Staff Report

To: Development Review Board
From: Christopher Yuen, Community Development Director
Date: 04/18/2023
Subject: Final Plan review for Autumn Pond Phase II

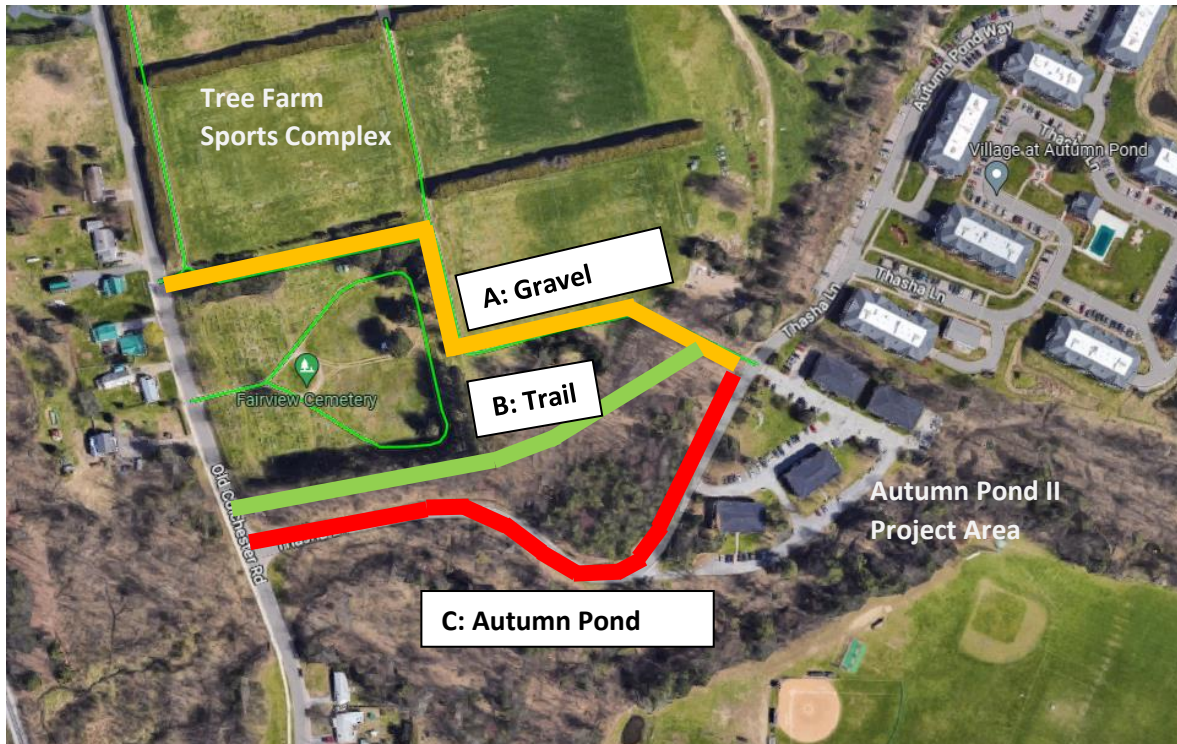
The applicant proposes to widen the Autumn Pond Road pavement to 28', as specified in Public Works Standards; however, the proposal does not include a 5' sidewalk, as specified in the LDC. Pedestrian access is partially accommodated along adjacent paths and trails.

There are three ways to get from Old Colchester Road to the Autumn Pond project area. These are illustrated below:

- Route A is a gravel path towards, but for those traveling walking to the school, or destinations in the city center, it adds about five-hundred feet of out-of-direction travel, or about an additional two-minutes of walking.
- Route B is a direct, pleasant trail in the woods, with some steep grades which may be challenging for some, or potentially impassible for those with mobility challenges, especially in the winter.
- Route C is Autumn Pond Way, the paved access road proposed to be widened to 28 feet, but without lighting or other accommodations for pedestrians. Despite this, it is likely to be the most common walking path to reach Old Colchester Road for non-recreational trip since it is flat, reasonably direct, and maintained in the winter.

Staff recognizes that the existing gravel path and trail partially fills the need for pedestrian access for Autumn Pond residents; however, Autumn Pond Way remains the only universally accessible direct route. We recommend that a sidewalk be provided, but if that is not feasible, the following options may mitigate some risks for pedestrians travelling along Autumn Pond Way:

- Painted 4' shoulders on each side of the 28' wide pavement would visually narrow the street, encourage slower motor vehicle speeds while creating safer space on for pedestrians and cyclists. Regular restriping would be necessary to ensure the lines remain visible. Refer to the [Small Town and Rural Design Guide](#) for more details on this treatment.
- Street lighting to improve comfort and safety for those walking or cycling along Autumn Pond Way.

The DRB should review plans for pedestrian and bicycle access from the Autumn Pond apartments to Old Colchester Road and provide direction on whether additional improvements are necessary.
